RE: Non-substantive and Substantive amendments to Development Agreement Case 16775 to enable 16' townhomes on PID 41470741

West Bedford Holdings Limited is requesting amendments to existing Development Agreement (Case 16775 as amended) for Bedford West Sub Area 5, to enable the development of 21, 16-foot wide condo/cluster townhouse units on the southern portion of Block A-11 (PID 41470741) where a multiple unit residential building is currently enabled. In order to permit this development, we understand that the following amendments to the existing Development Agreement are required:

Figure 2 – Excerpt of updated Schedules O-2 (left) and Schedule B-1 (right), now showing the townhouse land use

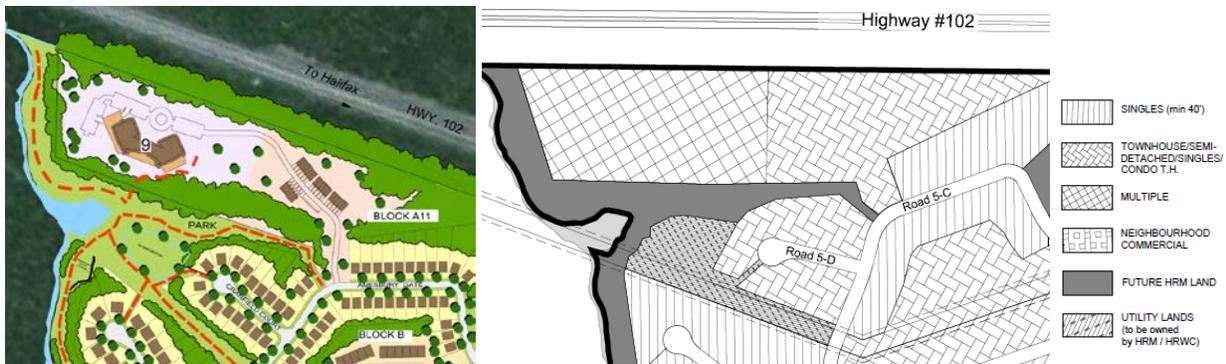
The proposed location of these condo/cluster townhouse units will require a change in land use, replacing the 6 storey multiple residential building that is currently shown on the concept plan, with a the condo/cluster townhouse use. We therefore are requesting revisions to Schedule O-1 and Schedule B of the existing agreement. Full revised versions of each are included as Attachments 3 and 4.

The proposed condo/cluster townhouses are a less intense use than originally planned. The change in height and mass of the structure adjacent to the existing residential homes along Amesbury Gate would have a positive impact on the adjacent property owners, and streetscape. The proposed townhouses will be significantly setback from the rear yards of existing single family residential, with the closest townhouse being over 65 m from the nearest single family dwelling along Amesbury Gate. A thick vegetative buffer will be maintained in the rear yard of the single family dwellings abutting this property, guaranteed by the watercourse and buffer between them, restricting any disturbance. The townhouses will however, be visible from the public street, along the private driveway, which will

SITE PLAN

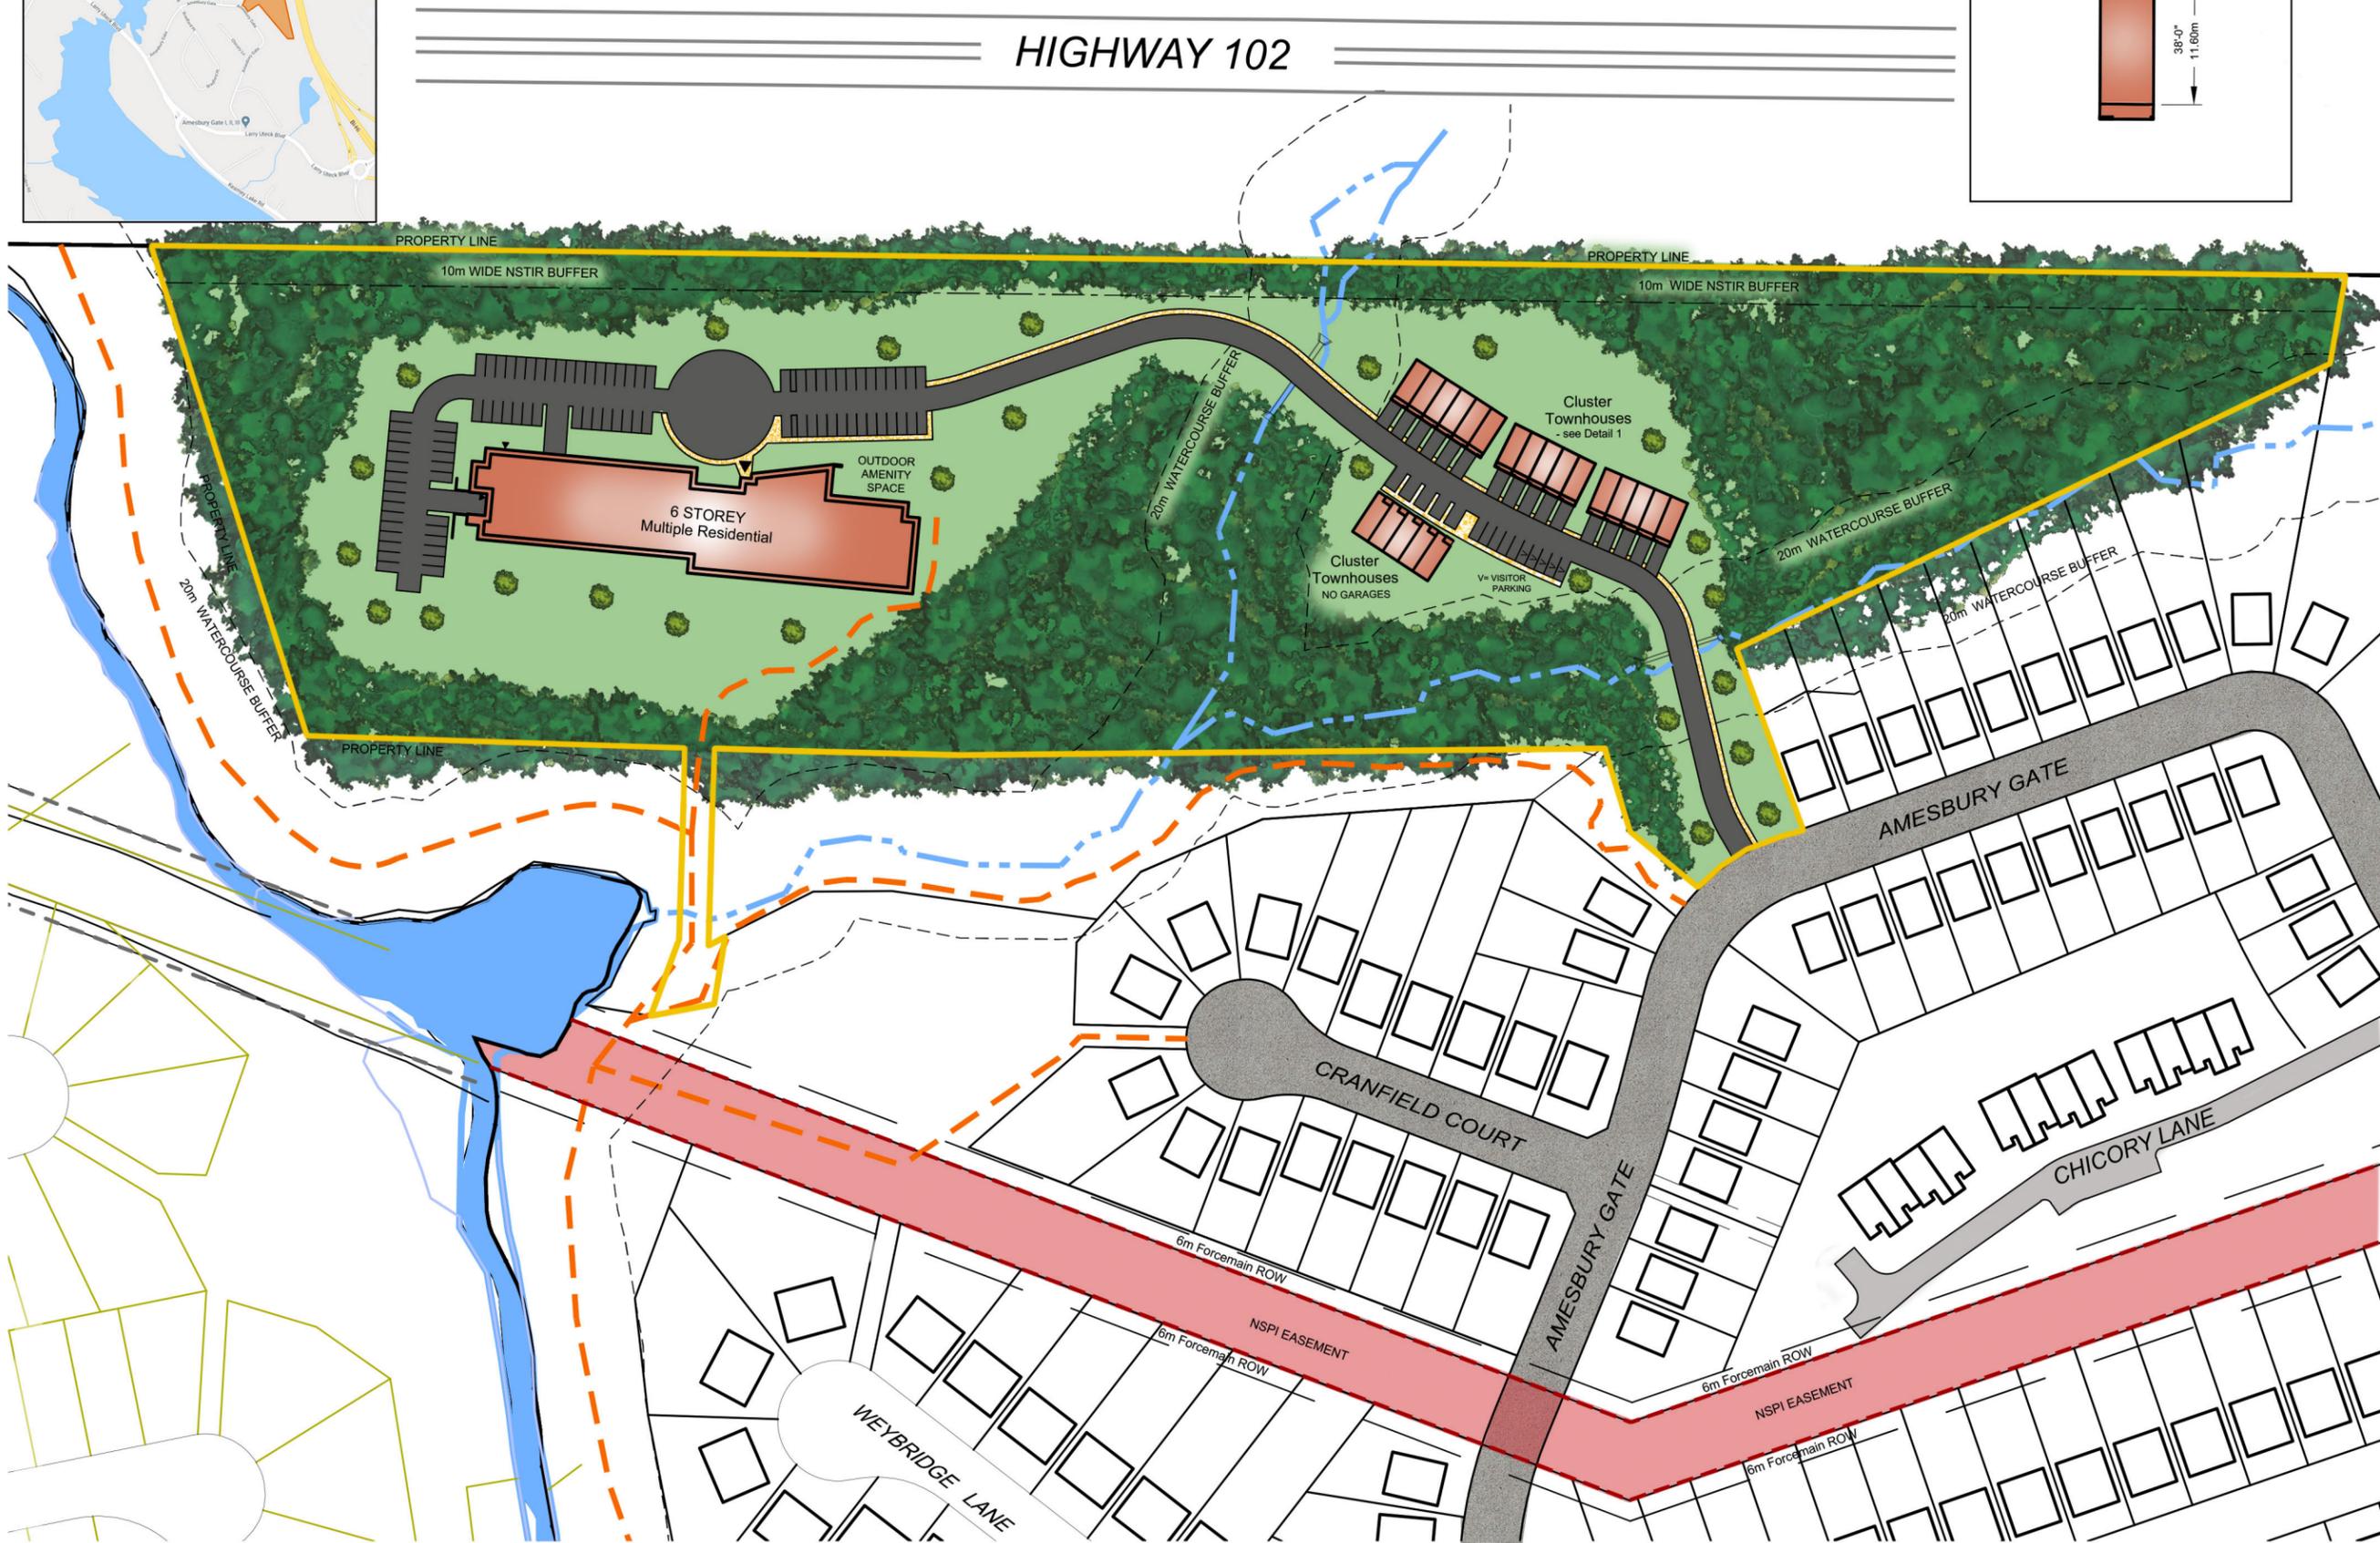
The townhouses are proposed to be developed in a condo/cluster format, located on a private driveway, shared with the multiple residential building to be located further north on the site. The majority of units (16 out of 21) are proposed to have their own interior garage and an individual driveway. Five units on the west side of the driveway are designed to have an individual driveway, and additional exterior surface parking adjacent to the building. All units have a ratio of 2.0 spaces per unit, as well as several dedicated visitor spaces. See Figure 1 below, and Attachment 2, for the site plan.
